2026-09-23 Peter Blackwood-Barrytown Minerals Project Fast Track Consent Application- Advice on Fast Track Panel Questions 4 and 5

The location of the streams is shown in Figure 1 of reference 1 and is reproduced overleaf.

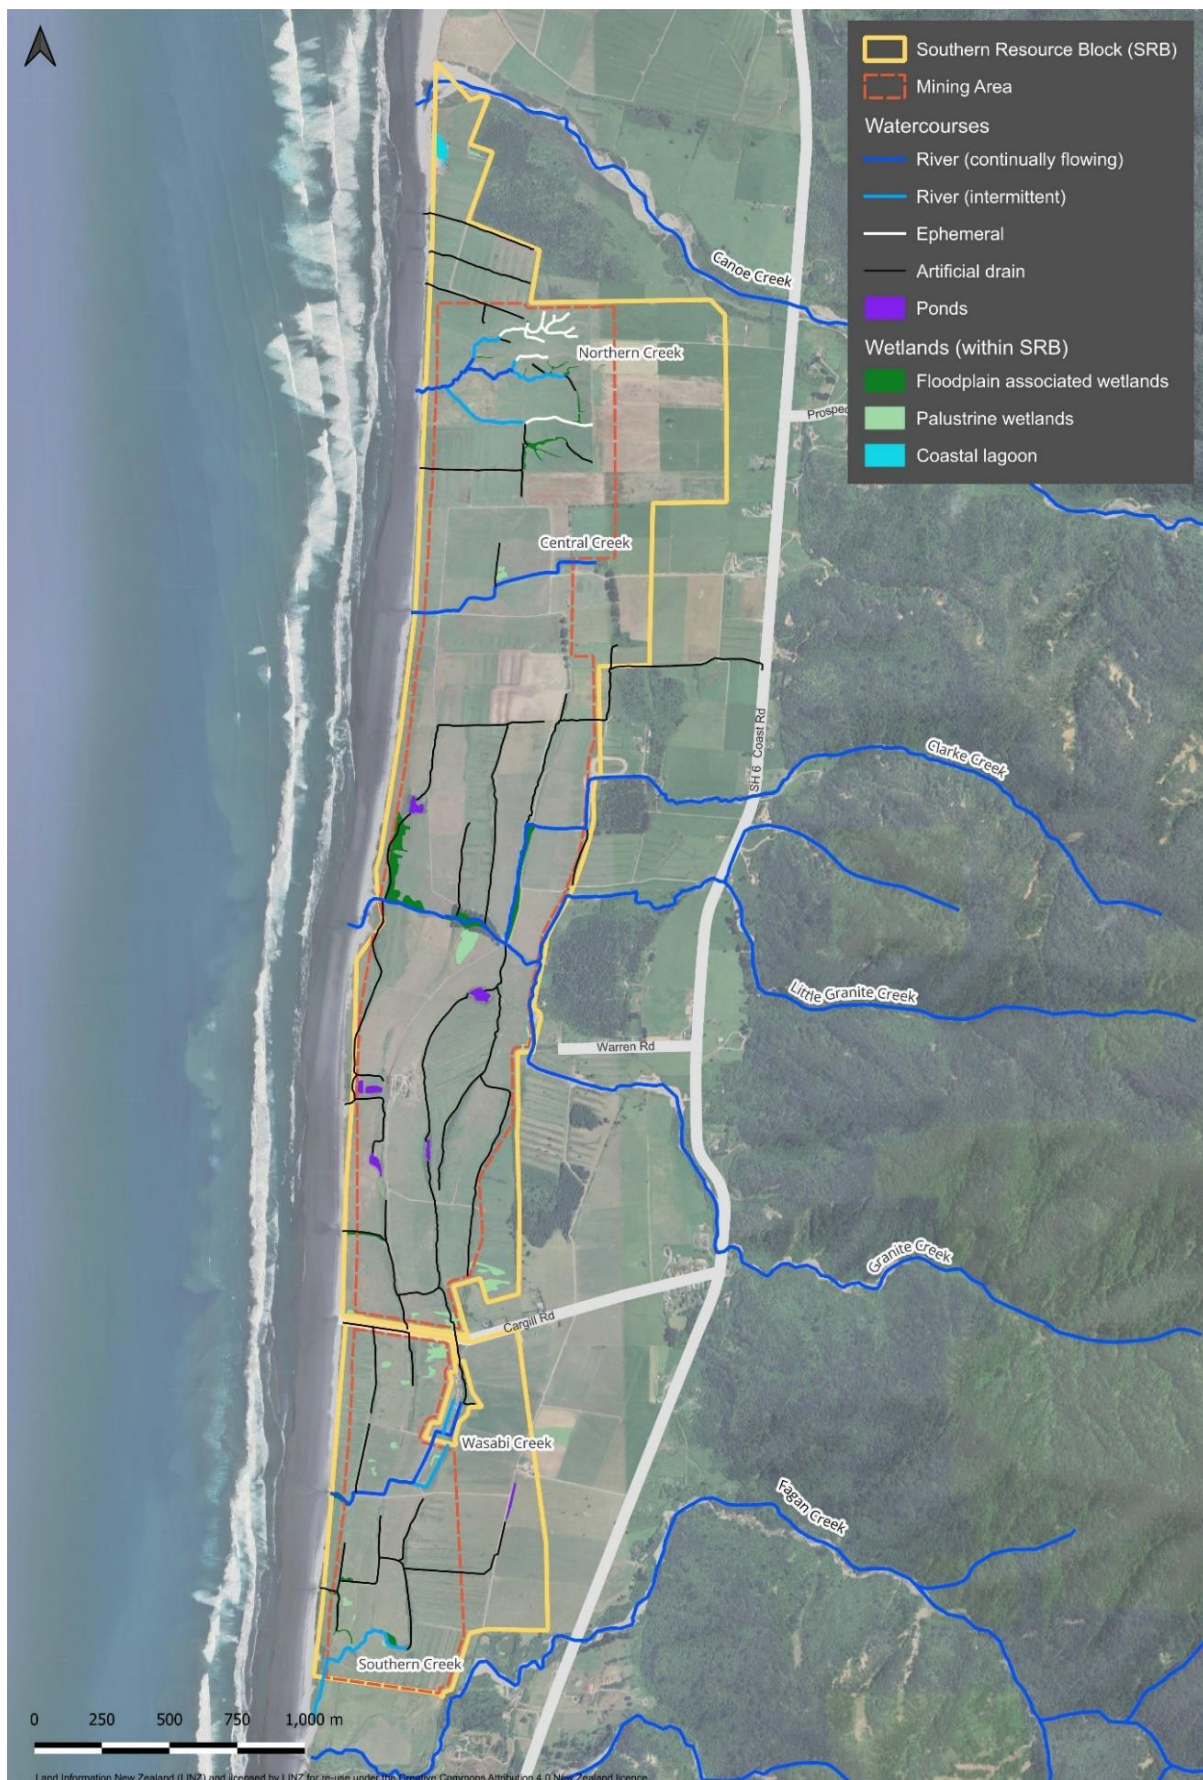
Most, if not all of these streams are highly modified streams (or drains). In terms of my area of expertise I agree entirely with the design principles listed in Section 5.3 of reference 1 (is actually section 6.3 for clarity). These are:

Even though these channels are generally significantly modified, they would have largely achieved a shape (cross-section) and slope to harmoniously interact with the adjacent floodplain in the current streams morphology.

I have not seen any complaint about the current shape and slope. From inspection of Figure 12 of reference 2, the average slope of Granite Creek for the approximately 2km downstream of SH6 is around 2%, with slope greater than that near SH6 and lesser near the Tasman Sea. This appears to be a harmonious state and should be reproduced in the rehabilitated channel. I would expect the slopes to be similar for Clarke Creek. The other watercourses are all only in the lower floodplain, with lesser slopes.

A baseline survey of the stream inverts should be conducted; together with survey of the predominant channel cross-sections. Ideally this would be completed by a skilled drone operator, with representative cross-sections surveyed at regular intervals – maybe every 100m.

1. Prior to any waterbody is interfered with a formal survey shall be completed of the channel invert level and regular cross-sections, at a minimum of 100 metre intervals. This survey shall commence at least 100 metres upstream of the proposed new channel and terminate 100 metres downstream of the channel.
